Americold Prospect Expansion SSD 9577613 - SEARs Request

Subject: Request for SEARs for Americold Prospect Expansion, 554-562 Reservoir Road, Prospect (SSD 9577613)

**SITE: 554 - 556 RESERVOIR ROAD, PROSPECT
SUBJECT: APPLICATION FOR SECRETARY'S ENVIRONMENTAL ASSESSMENT
REQUIREMENTS (SEARs) FOR THE PROPOSED EXPANSION OF EXISTING AMERICOLD
FACILITY AT 554-556 RESERVOIR ROAD, PROSPECT**

Project Name: AmeriCold Prospect Expansion
SSD #: 9577613

A4.3 - Padmount easements and clearances

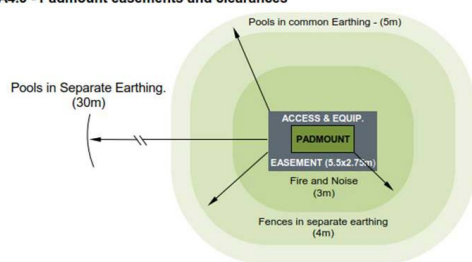
- Padmount substation no. 18399 as shown in the following Figure A4.3 'Padmount easements and clearances', from Endeavour Energy's Mains Design Instruction MDI 0044 'Easements and Property Tenure Rights', requires:
 - Easement with a minimum size of 2.75 x 5.5 metres (single transformer)
 - Restriction for fire rating which usually extends 3 metres horizontally from the base of the substation footing and 6 metres vertically from the same point.
 - Restriction for swimming pools which extends 5 metres from the easement.
